1. Project # 21-1008: Princeton Subdivision Plat 1 Lot 7 – Site Plan Amendment

TO: Planning and Zoning Commission
FROM: Evann Martin, Assistant Planner
DATE: April 6, 2021
RE: Princeton Subdivision Plat 1 Lot 7 – Site Plan Amendment

RE: 1884 SE Destination Drive Site Plan Amendment (Princeton Subdivision Lot 7)

LOT 7, PRINCETON SUBDIVISION, PLAT 1
PHASE 2
UTILITY PLAN

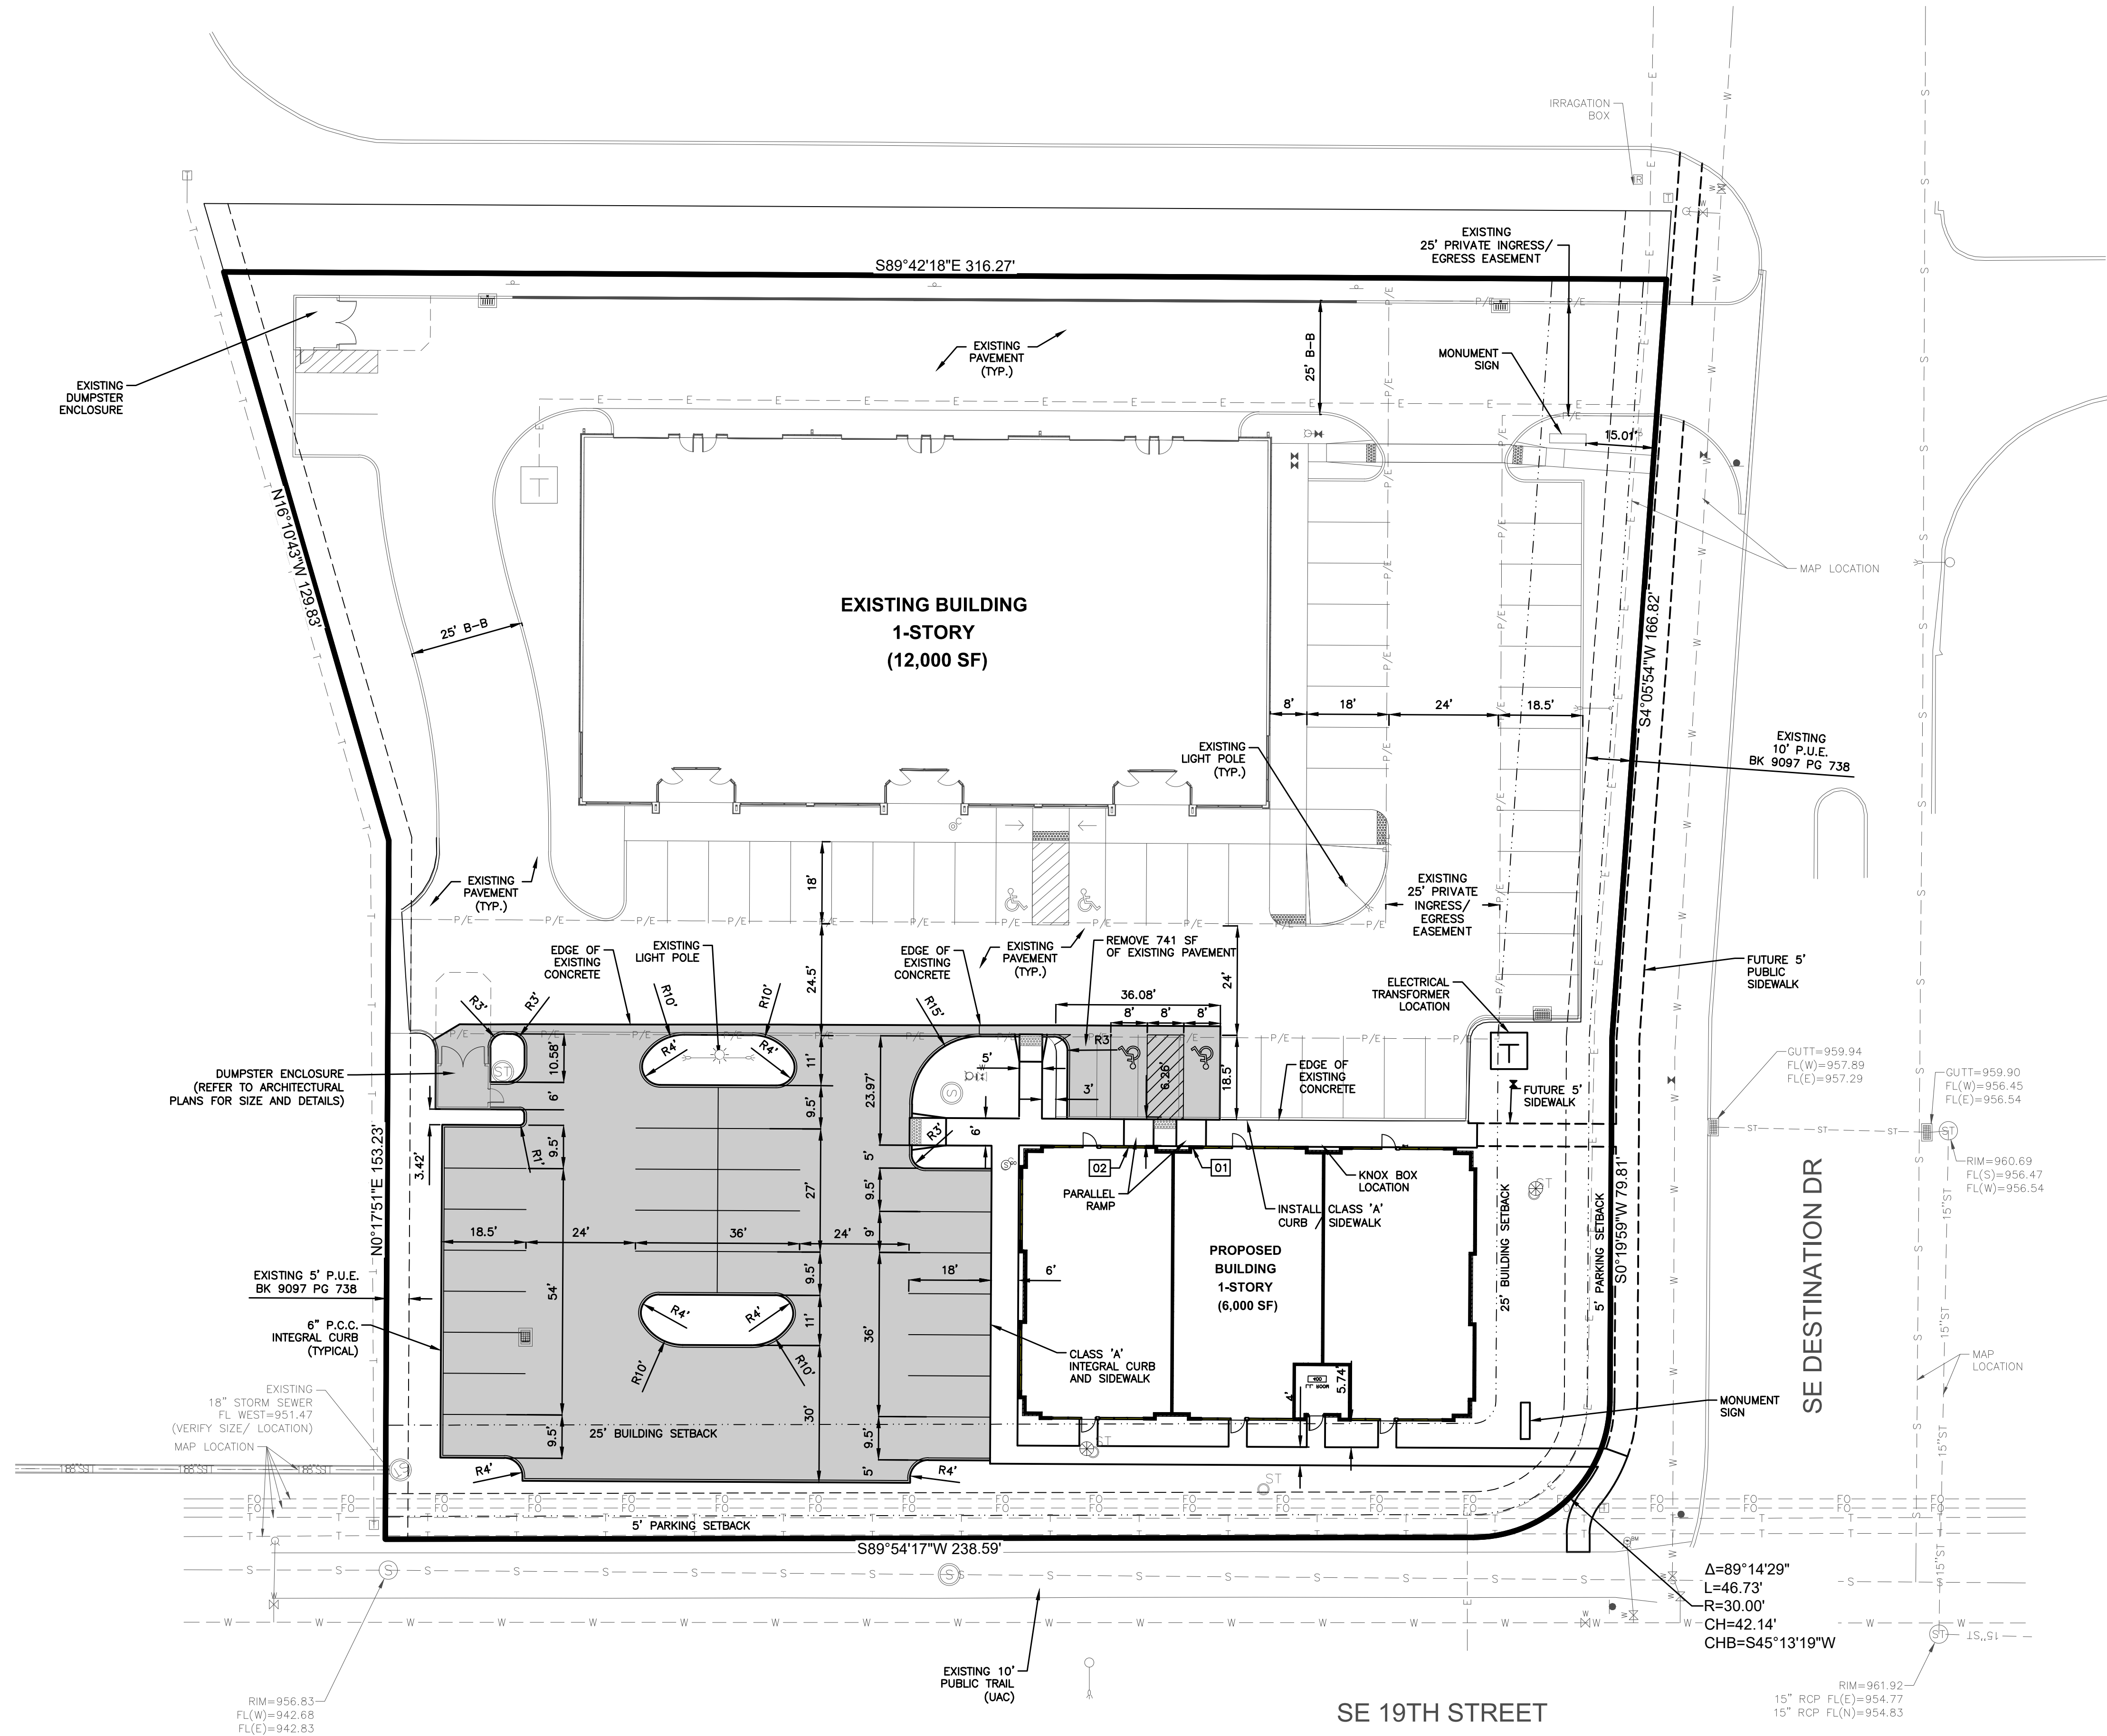
3. Add City of Grimes standard notes for site plans. **Update with current notes. Attached.**
4. ~~The revised utility drawing for Building #1 (Revised Final Submittal date of 11/21/19) shows water services coming from the south to the SE building corner and from east to the NE building corner. Confirm water services to the SE bldg. corner~~

7. Provide roof drain connections.

8. Please move the FDC to within 100' of the hydrant. Preferably on the same corner of the building as the hydrant.

LOT 7, PRINCETON SUBDIVISION, PLAT 1 PHASE 2 DIMENSION PLAN

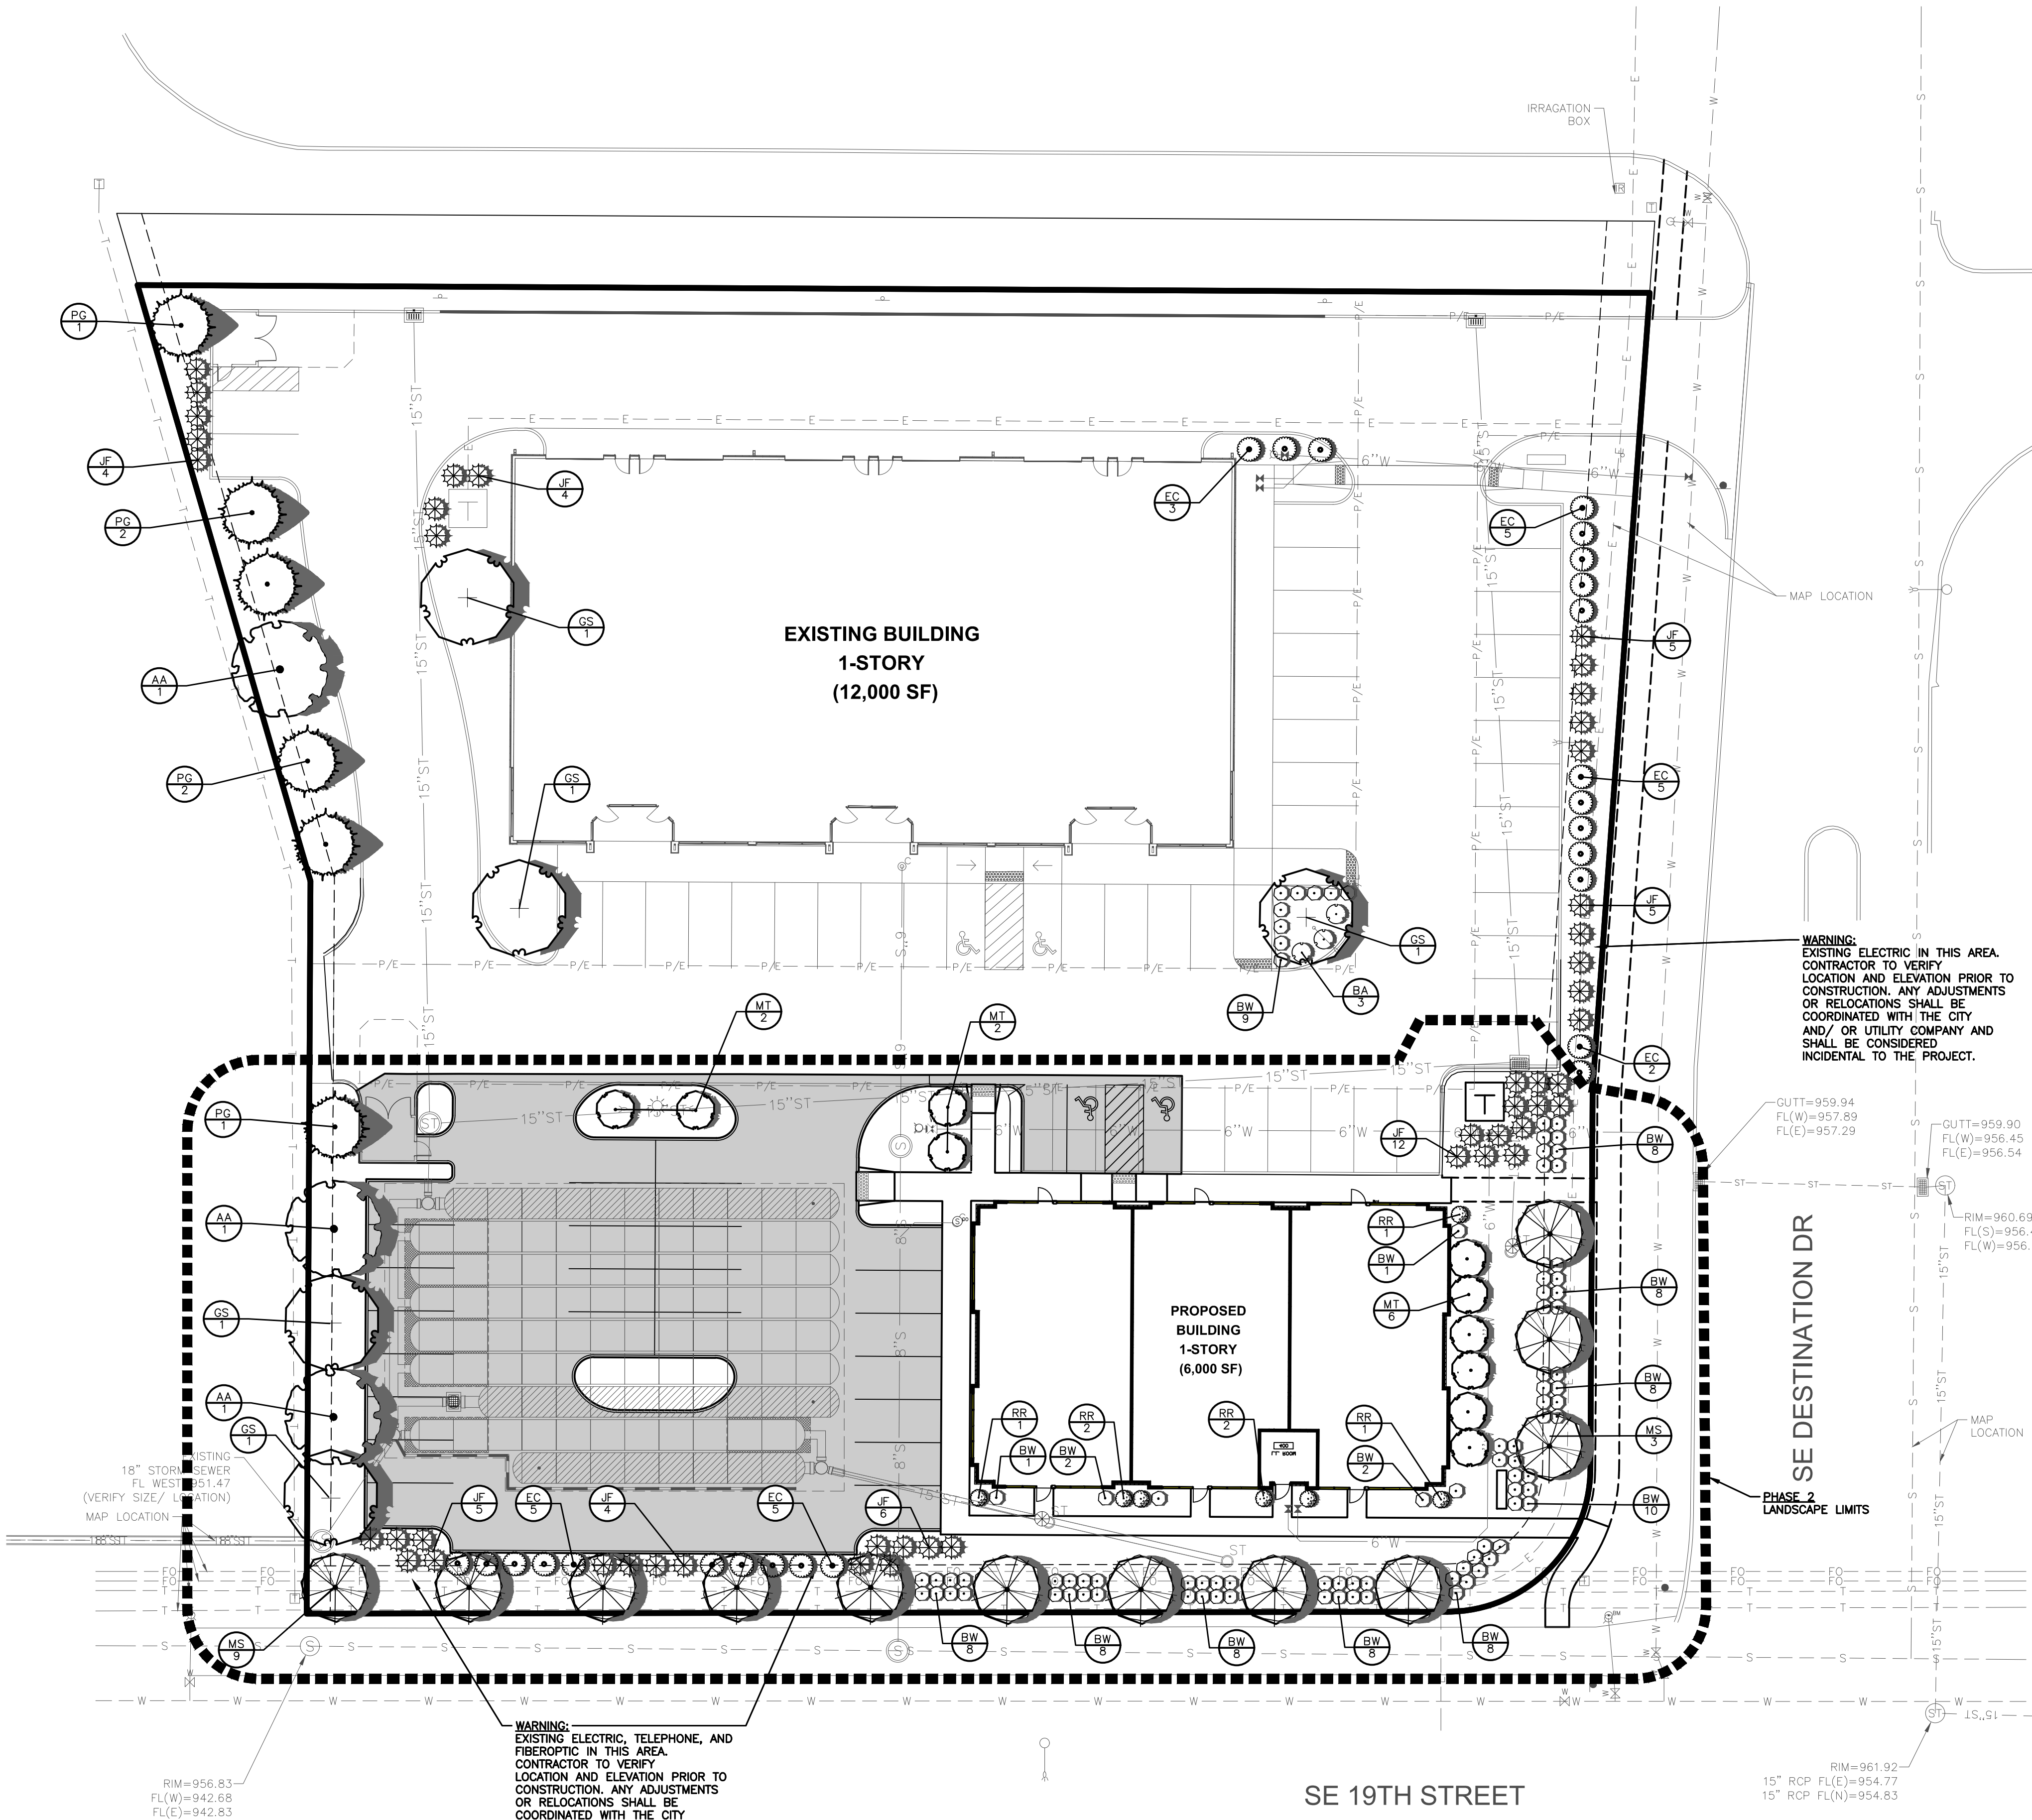
Sheet 2.0 Dimension Plan

1. ~~Under General Note #5 change construction division to Engineering Dept.~~
2. ~~Please move the ADA spaces to the north side of the building where they will have the shortest accessible route.~~

DWG. LIST
COLOR EXTERIOR
ELEVATIONS

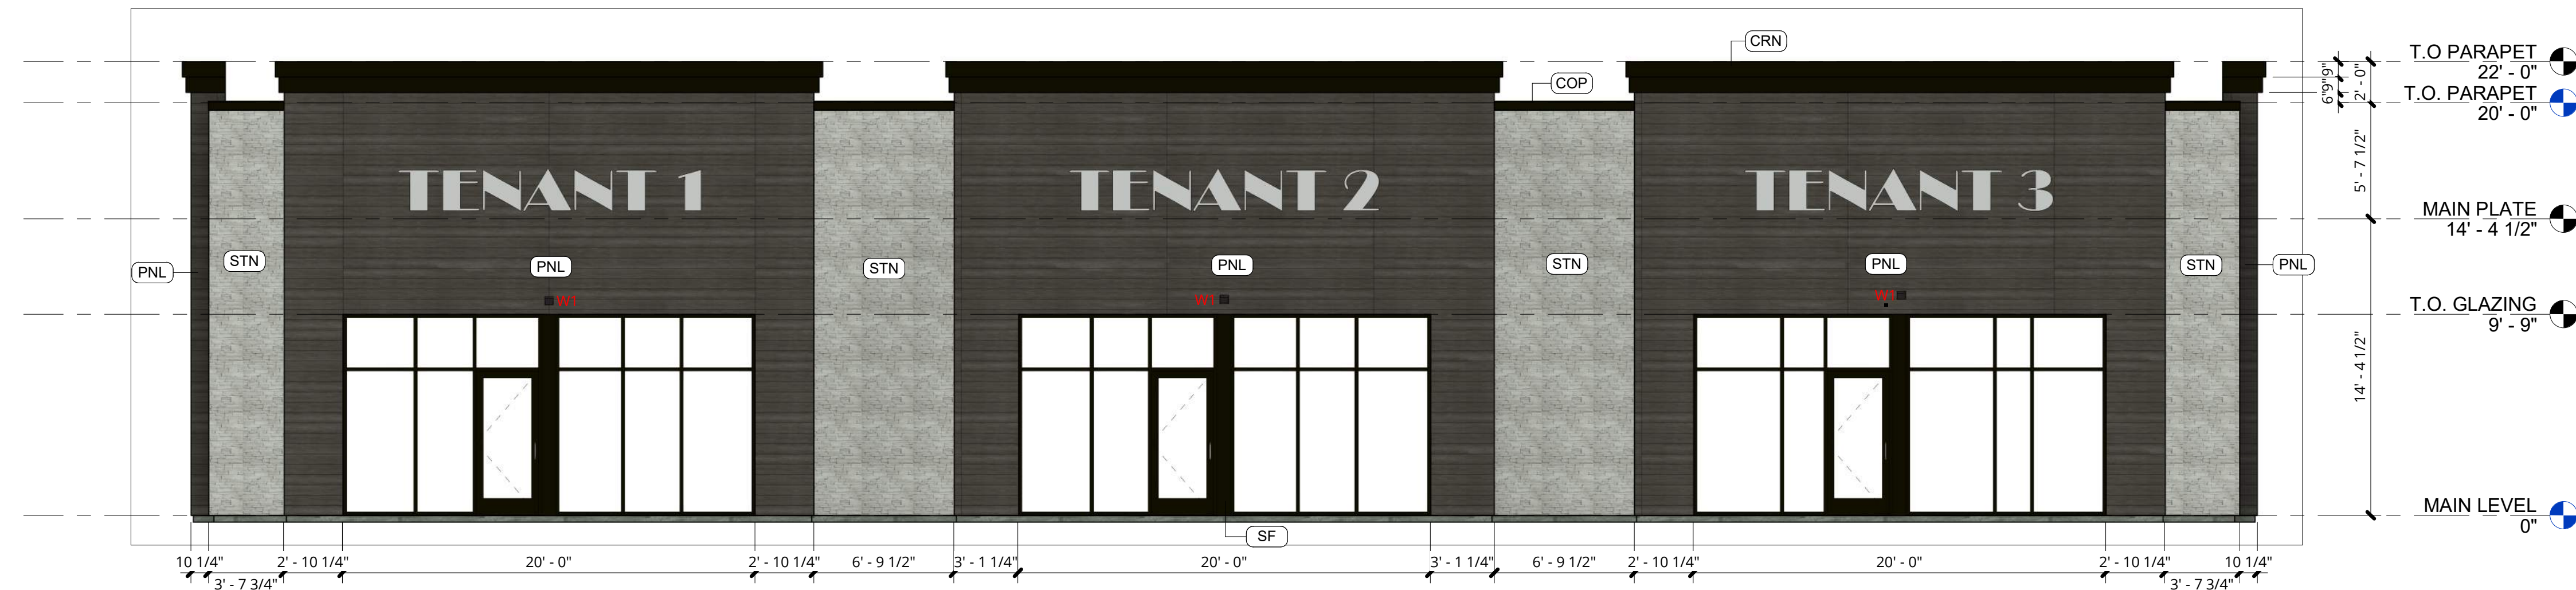
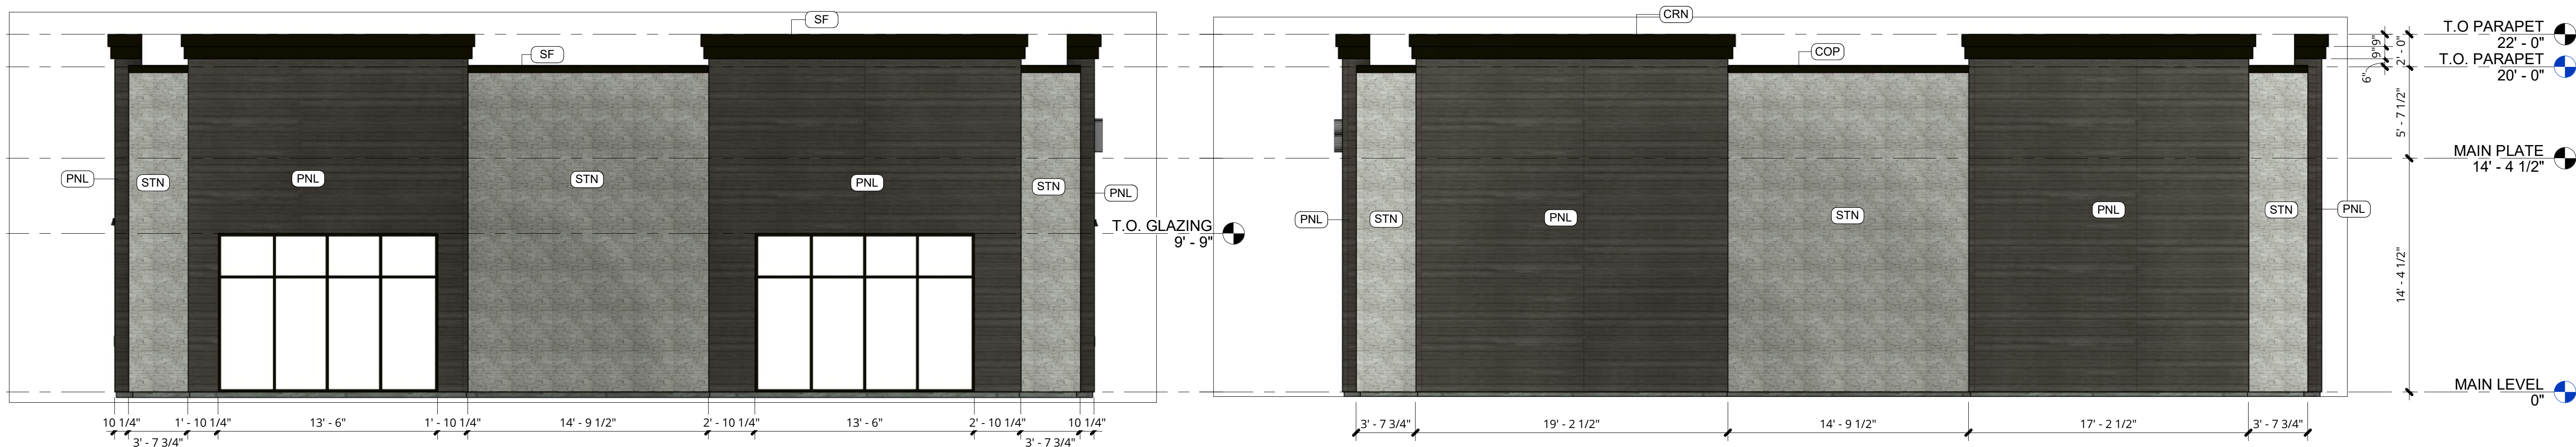
1. Provide lighting cut sheets and photometric plan. Up lighting is required on building faces along ROW. Please provide up lighting on the building. Different light fixtures could be provided or lights could be added to shine from the ground.

2. Show wall lighting locations on the elevation drawings. Are there any other light fixtures proposed? Any LED light strips or colored lighting? All lighting will need to be detailed on the elevations. If the lighting design is changed after the elevations are approved by P&Z and Council, the elevations will need to go back for approval.
